TOLEDO - LUCAS COUNTY PLAN COMMISSIONS

REF: SUP24-00092

SUBJECT: Special Use Permit for Gas Station and Convenience Store at 3219 Tremainsville Road

SITE PLAN

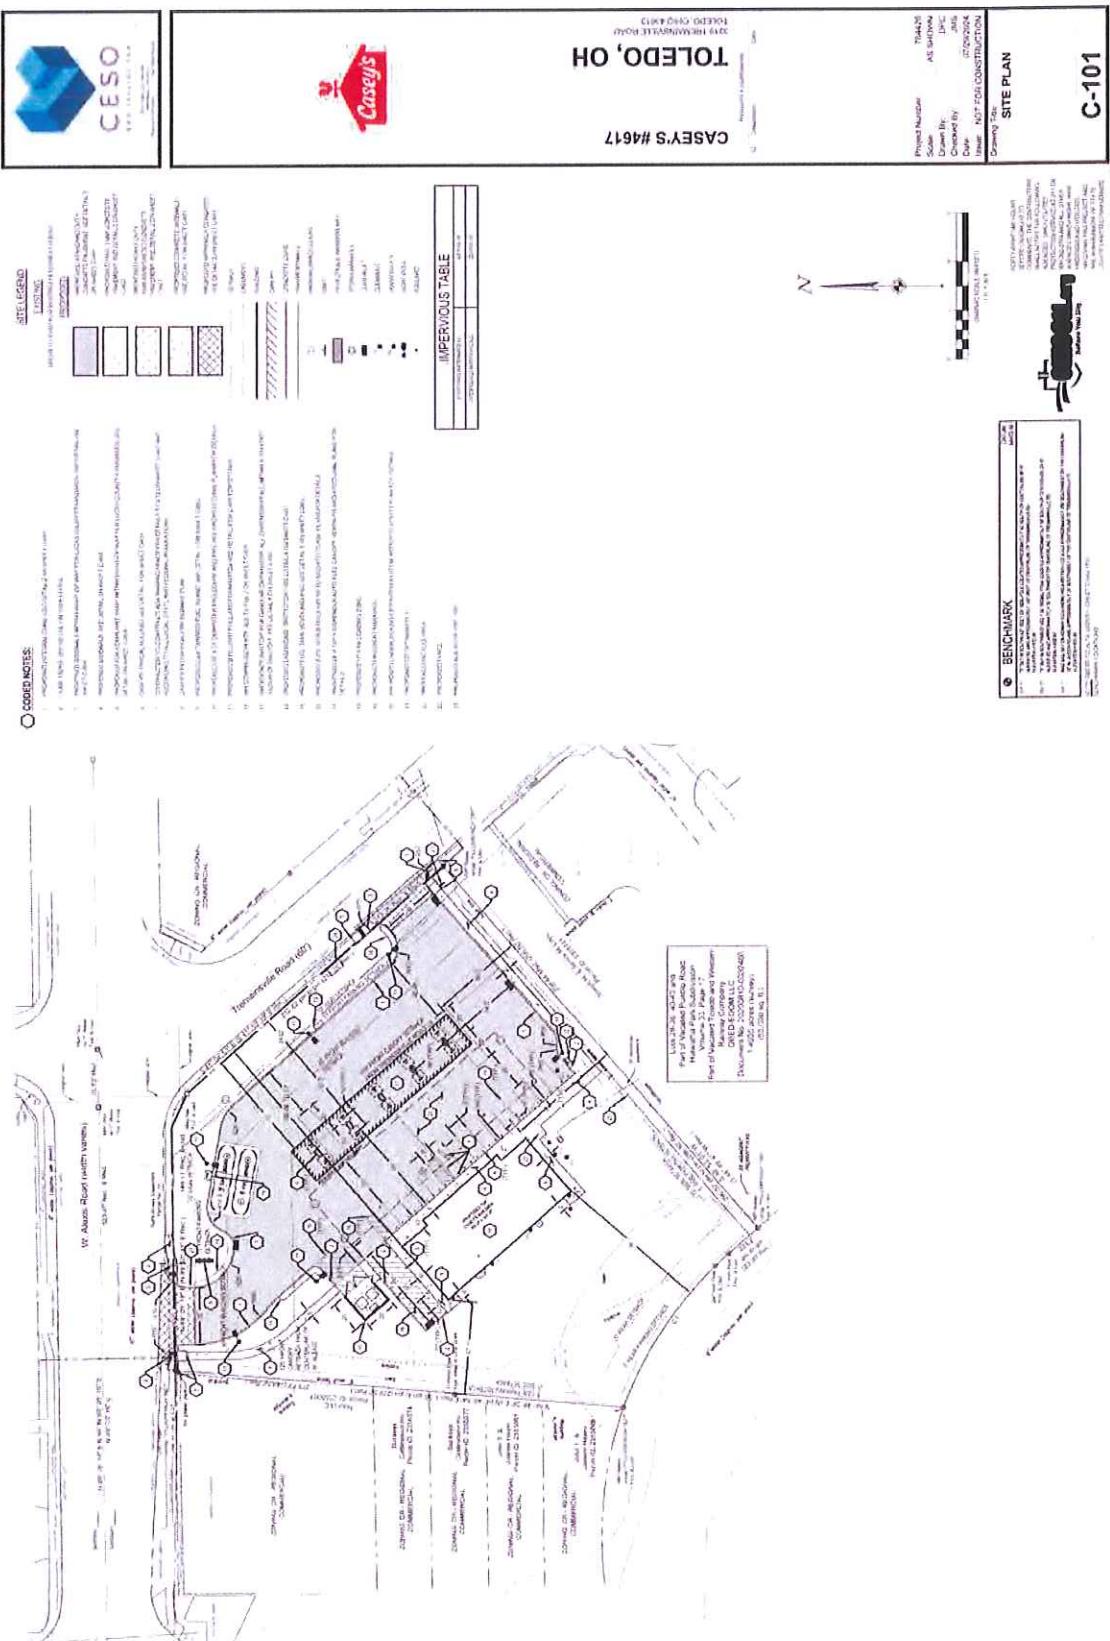
TMC§1107.0300 *Off-Street Parking Schedule "A"* requires a minimum of twenty-five (25) off-street parking spaces for the proposed gas station / convenience store. The site plan depicts sixteen (16) off-street parking spaces and has been deemed acceptable by the Planning Director as the applicant is offering a sheltered bus-stop on site, which offers a reduction in parking needs per TMC§1107.1407(E) *Transit Stops*.

Based on the proposed parking spaces and TMC§1107.1700 *Accessible Parking*, one (1) van-accessible parking space with an 8-foot aisle abutting the space is required. Additionally, a minimum of two (2) bicycle spaces is required. The site plan shows both of these elements.

Per TMC§1109.0204(A) *Connecting Walkways*, at least one (1) main entrance of any commercial building shall face and open directly to a five-foot (5') wide connecting walkway to the street sidewalk. The site plan depicts two internal sidewalks that connect to the street sidewalks and will allow pedestrians to access the site from both Alexis Road and Tremainsville Road.

(TMC§1107.0304). A total of twenty-five (25) parking spaces are required for this site. The submitted site plan shows sixteen (16) parking spaces. **Acceptable as depicted, given that the applicant is providing a covered bus shelter as a pedestrian amenity on-site.**

39. Bicycle parking slots shall be provided pursuant to Off-Street Parking Schedule "A," (TMC§1107.0300). Minimum number of bicycle parking slots required for a convenience store is one (1) bicycle parking per ten (10) parking spaces. A minimum of two (2) bicycle parking spaces is required. **Acceptable as depicted.**

41. Any spaces reserved for the use by persons with physical disabilities shall adhere to the standards outlined in TMC§1107.1700. One (1) van accessible space with an eight-foot (8') drive aisle is required. **Acceptable as depicted.**

LANDSCAPE PLAN

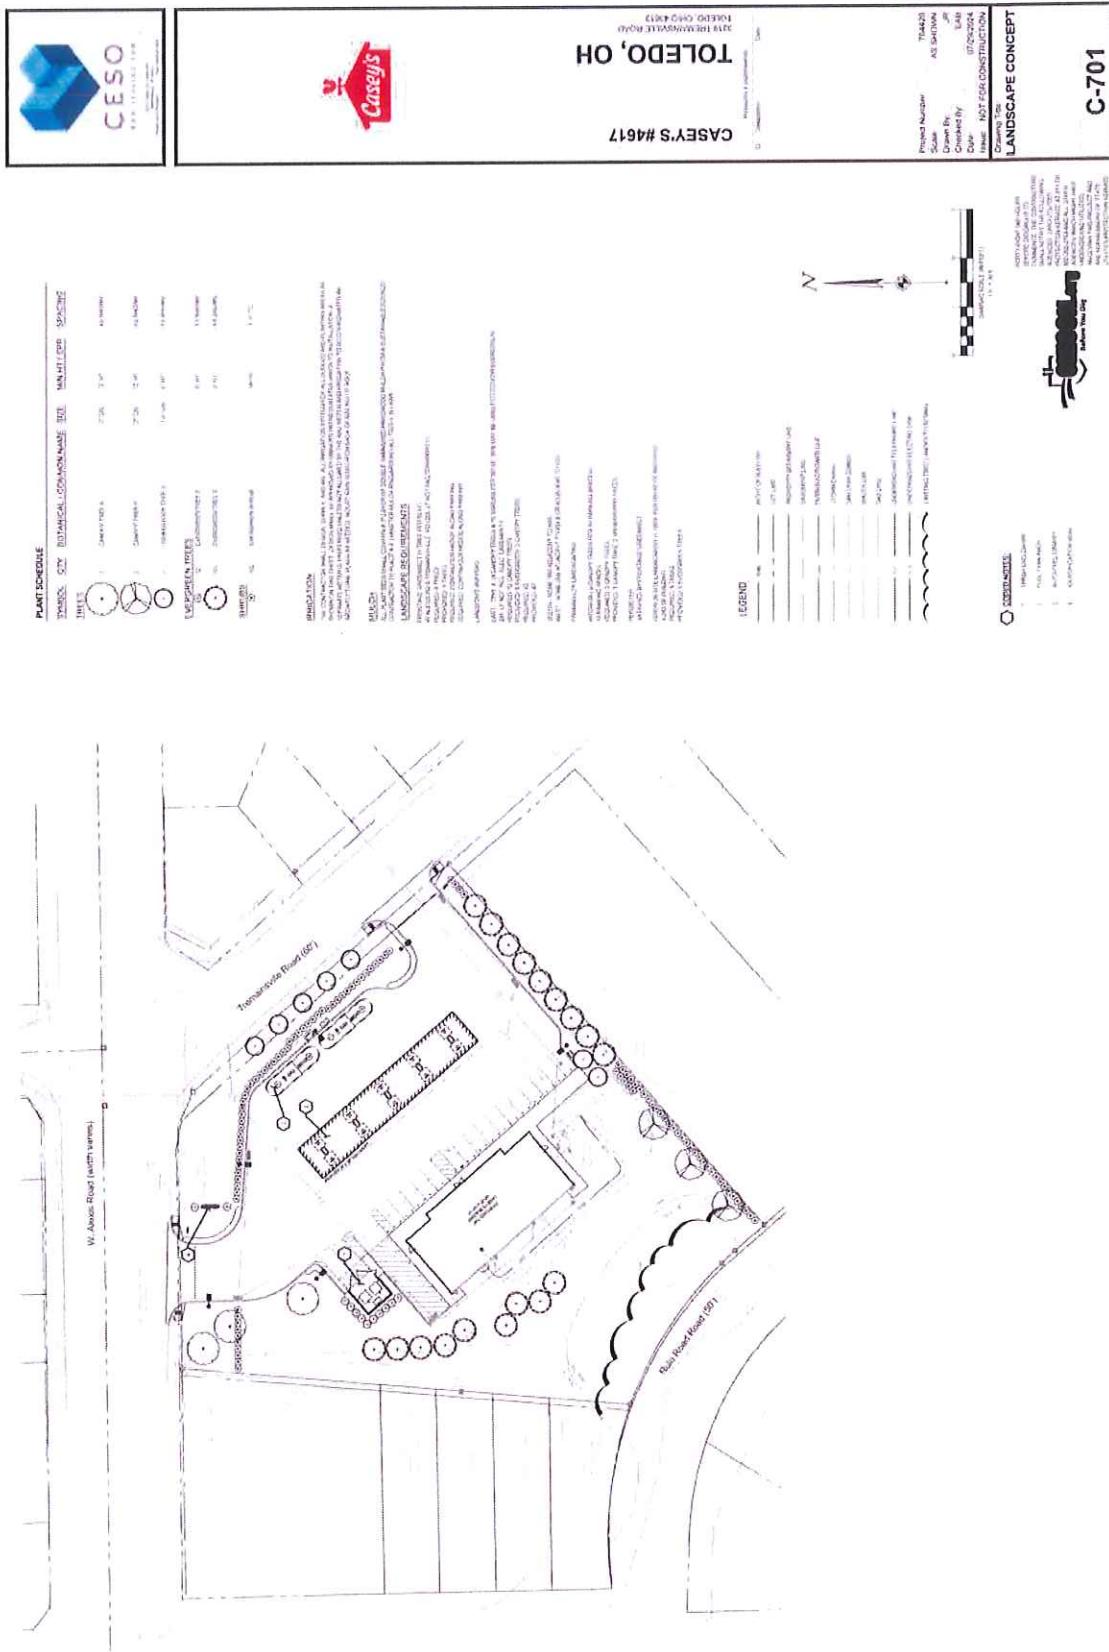
- a. A fifteen-foot (15') buffer of landscaped frontage greenbelt is required along Alexis Road and Tremainsville Road. At least one tree must be provided for every thirty feet (30') of lot frontage. The frontage greenbelt shall also include a solid evergreen hedge to screen parking in the front of the property and prevent headlights from being seen from the right-of-way. **Not acceptable as depicted.** A

revised landscaping plan shall be submitted depicting an additional five (5) trees in the frontage greenbelt.

- b. A Type A landscape buffer is required along the eastern property line where abutting the residentially zoned district. **Applicant shall extend the required Type A buffer the full length of the site's eastern edge to screen the single-family home to the east. Two (2) additional shrubs shall be added to a revised landscape plan to meet quantity requirements.**

- c. Two (2) canopy trees and six (6) shrubs are required to be installed in interior landscape areas for each ten (10) parking spaces within the parking lot. A total of three (3) trees and ten (10) shrubs are required for this site. **Not acceptable as depicted. Ten (10) additional shrubs shall be added a revised landscape plan to meet the quantity requirements for interior parking lot landscaping.**

- e. Foundation plantings shall be required along the portions of the building visible from the right-of-way. **Not acceptable as depicted. Foundation plantings shall be added along the western and northern elevations, which are visible from the right-of-way).**

EAST & NORTH ELEVATIONS

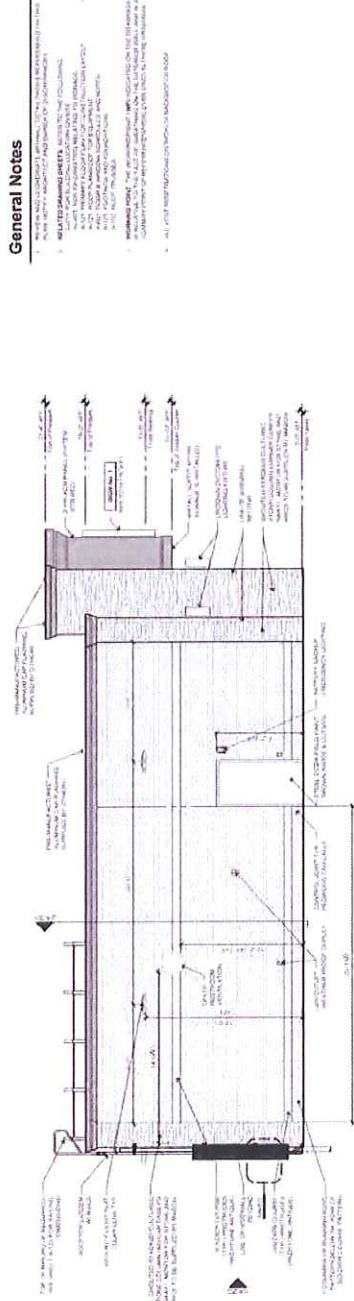
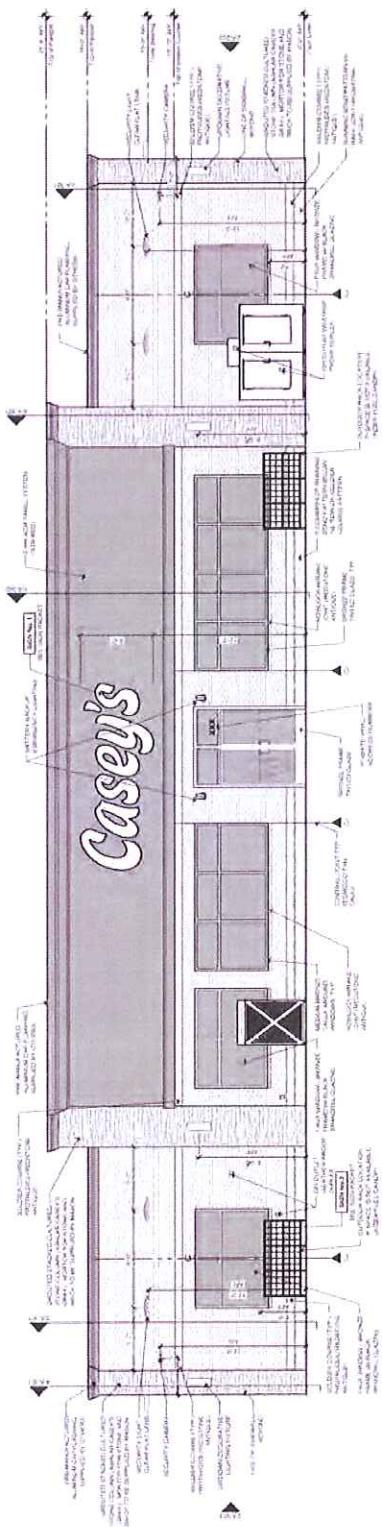
As required under TMC§1109.0500 *Building Façade Materials and Color*, the elevations must show that at least eighty percent (80%) of each elevation visible from the right-of-way is comprised of allowable predominant materials and colors. This standard applies to the front façade, visible from Tremainsville Road, and the western façade, visible from Alexis Road. The façade facing Tremainsville Road is 41% brick, 20% architectural metal, 19% glass, and 10% stone, and 10% metal trim. The façade facing Alexis Road is 63% brick, 19% glass, 9% stone, and 5% metal trim. The proposed elevations on the main structure are compliant with TMC§1109.0500.

Finally, as per TMC§1109.0205 *Building Design Standards*, transparent windows shall occupy at least forty percent (40%) of the area between two and ten feet at grade from the base of the primary elevation facing the right-of-way. The proposed front elevation window coverage exceeds this area requirement; however, faux windows are proposed for a portion of the windows on the front façade. The applicant shall ensure that all windows along the front façade are transparent and not obstructed during business hours to meet the standards of this code section.

- a. Facing Tremainsville Road: 41% brick, 20% architectural metal, 19% glass, and 10% stone, and 10% metal trim.
- b. Facing Alexis Road is 63% brick, 19% glass, 9% stone, and 5% metal trim.

48. Per TMC§1109.0205, transparent windows shall occupy at least forty percent (40%) of the area between two and ten feet at grade from the base of the primary elevation facing the right-of-way. **Not acceptable as depicted. The proposed front elevation window coverage exceeds this area requirement; however, faux windows are proposed for a portion of the windows on the front façade. The applicant shall ensure that all windows along the front façade are transparent and not obstructed during business hours to meet the standards of this code section.**
